ONSITE SEWAGE DISPOSAL SYSTEM

PROPERTY ADDRESS: 15255 Sweetbay Street

RE: **15255 Sweetbay Street (Lot 35), BAT Site Plan: comment**

SITE PLAN FOR
BAT INSTALLATION

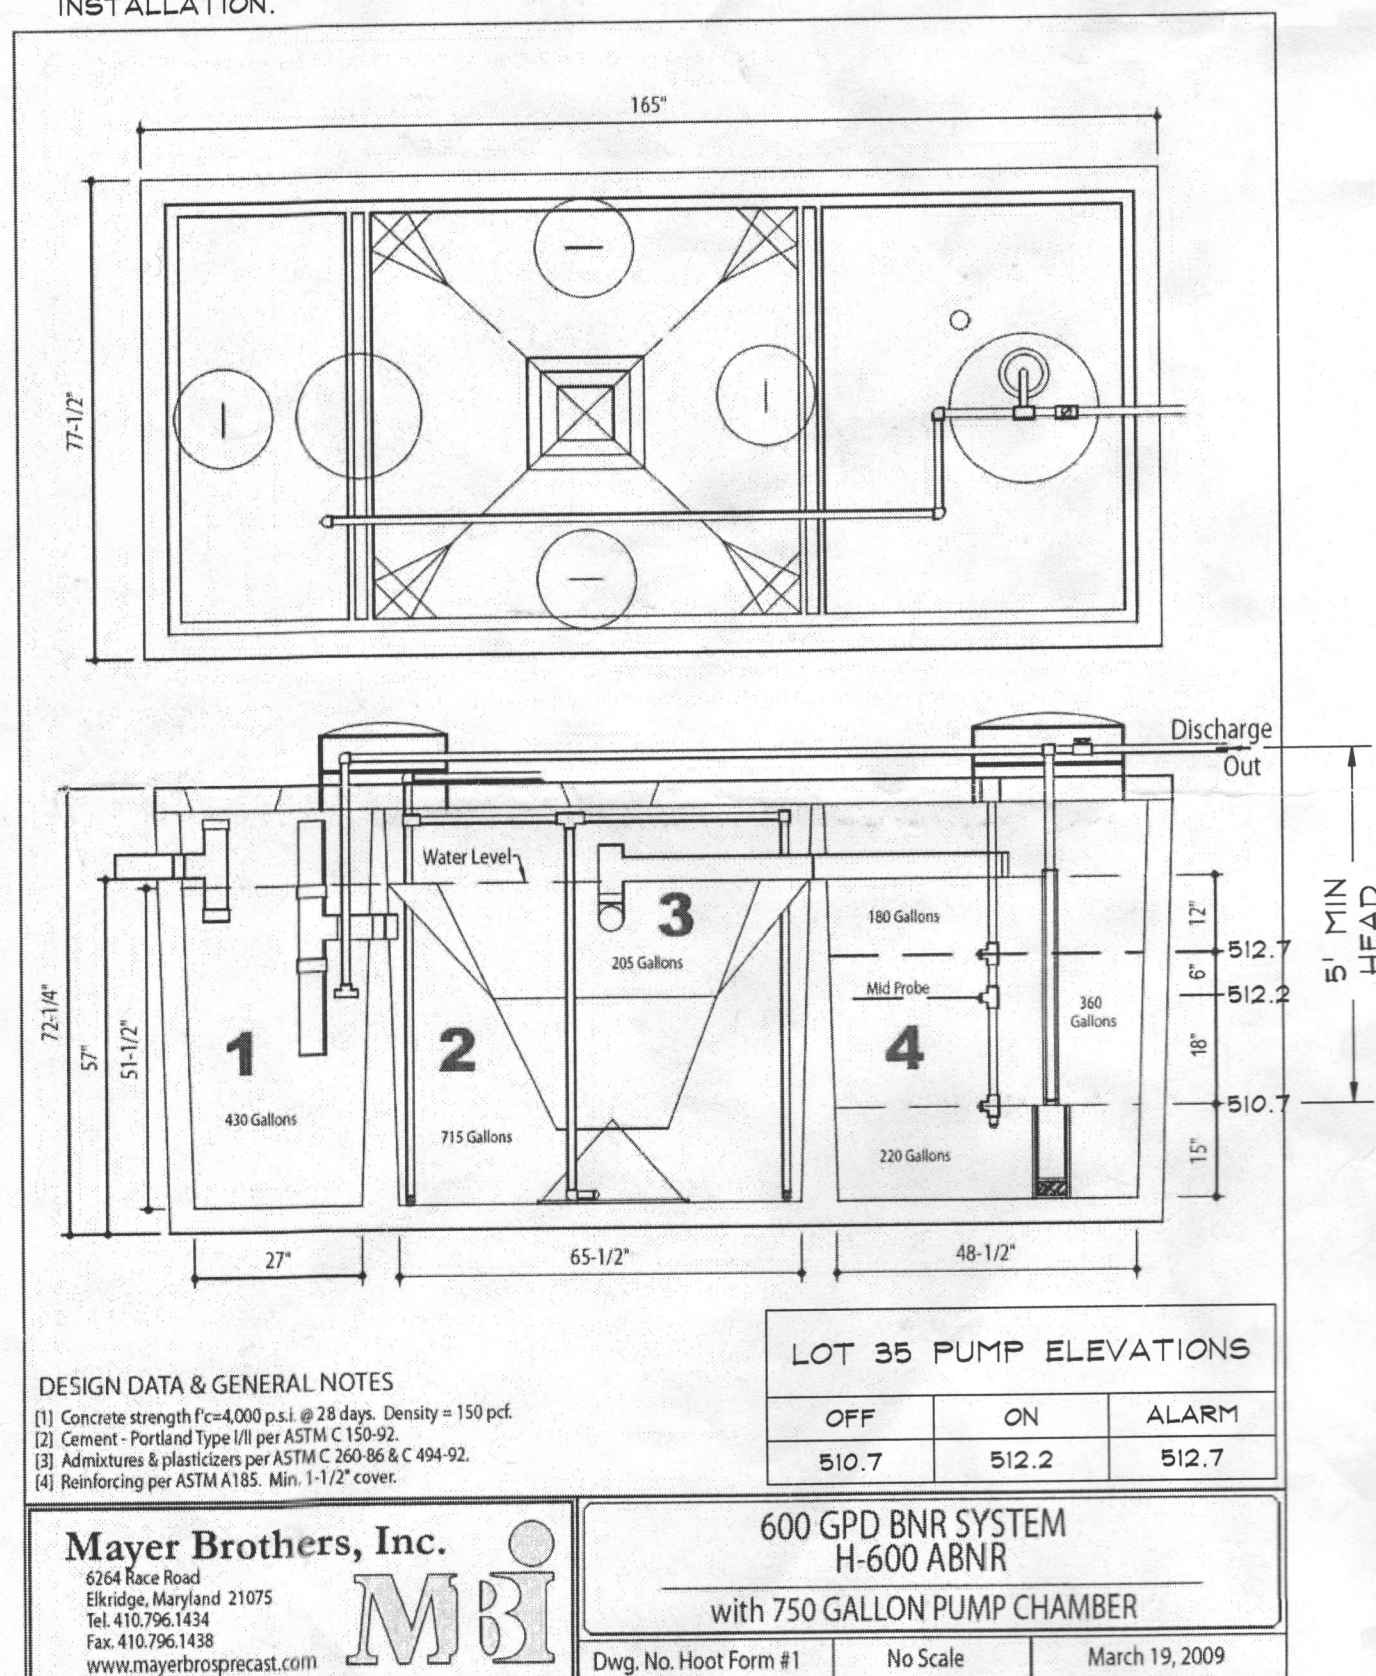
1. I have enclosed a mark-up of the Plan View illustrating the following:
 - a. re-orient the direction of the BAT unit and location of Blower
 - b. re-locate the Distribution Box

- c. re-locate the initial drainfield system to the uppermost region of the SDA
 - d. relocate the first replacement drainfield as indicated.
2. In Septic System Profile, edit the following:

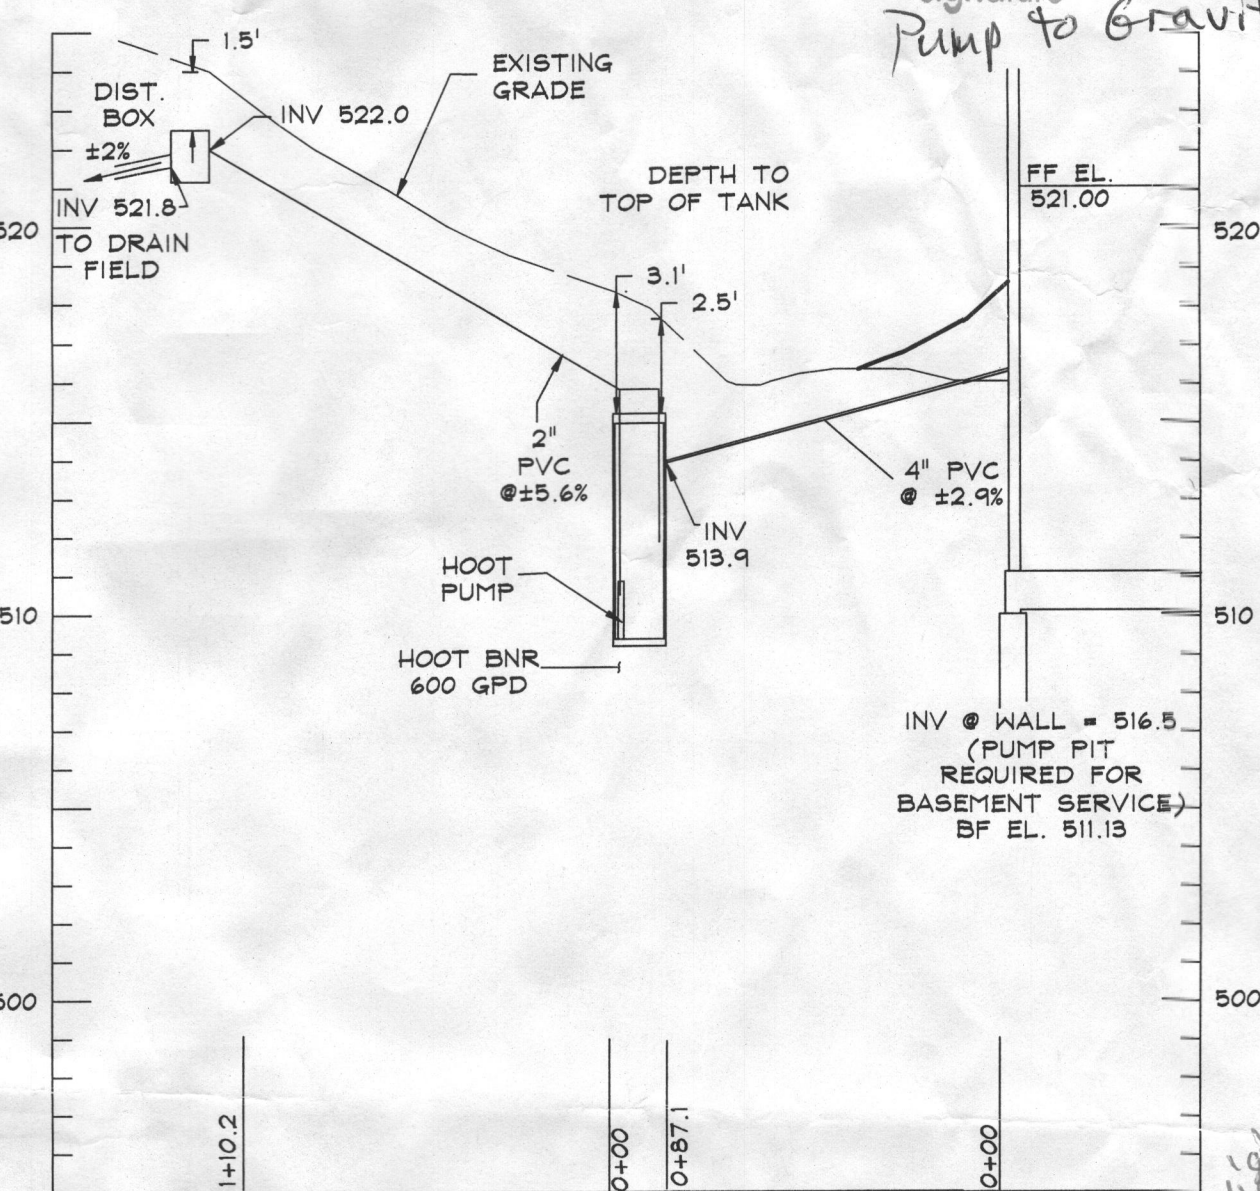
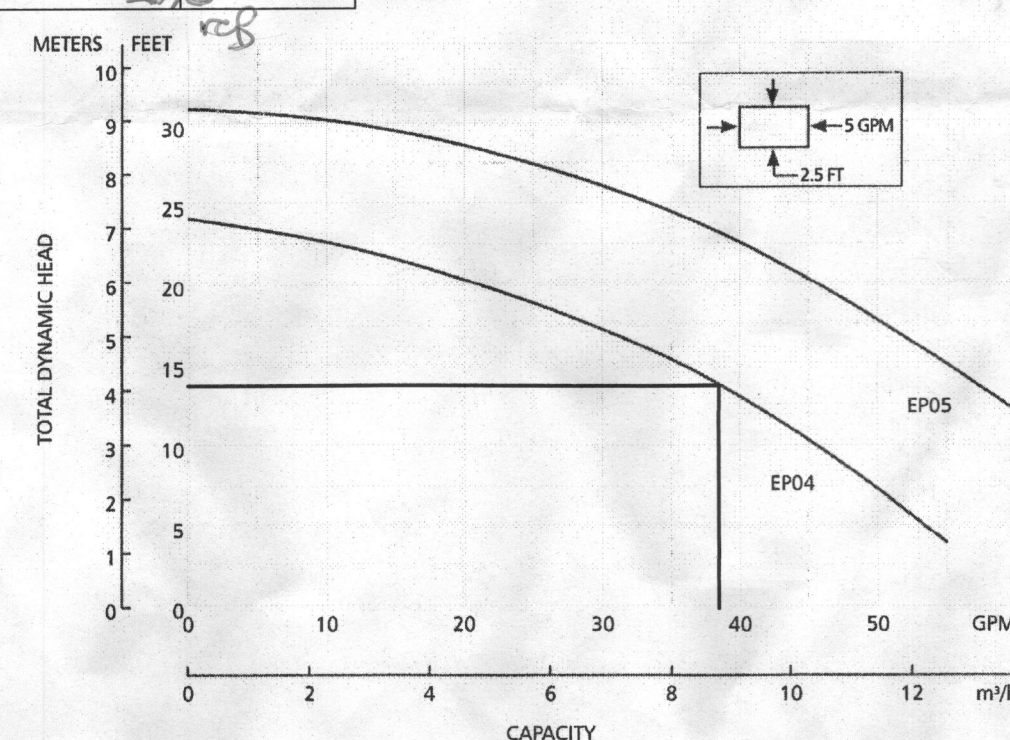
- a. Re-position the invert at the foundation wall making it equal or higher in elevation than the top of the BAT unit. (Thereby the entire volume of the BAT unit may store discharge from the house in the event of pump failure, and the wastewater doesn't back-up into the house until the tank is full.)

- b. Correct the height and relative elevation change for Inverts IN and OUT of Distribution Box. There is a drop of 1.3 feet across the Distribution Box. I recommend obtaining more accurate dimensions for Distribution Boxes and illustrating the height accurately.

3. Reconsider the Force Main design and calculations and impact on required size of Pump. For example, I have a reference for Charlotte Pipe and Foundry Company that describes 11.85 feet of Friction Head per 100 feet pipe length for 1 1/4" diameter Schedule 40 pipe at 30 gallons per minute, and having velocity of 6.63 ft/sec. In comparison, a 2" diameter Schedule 40 pipe at 30 gallons per minute has only 1.62 feet of Friction Head per 100 feet pipe length and velocity of 2.93 ft/sec.

4. Correct all calculations and elevations per edits.
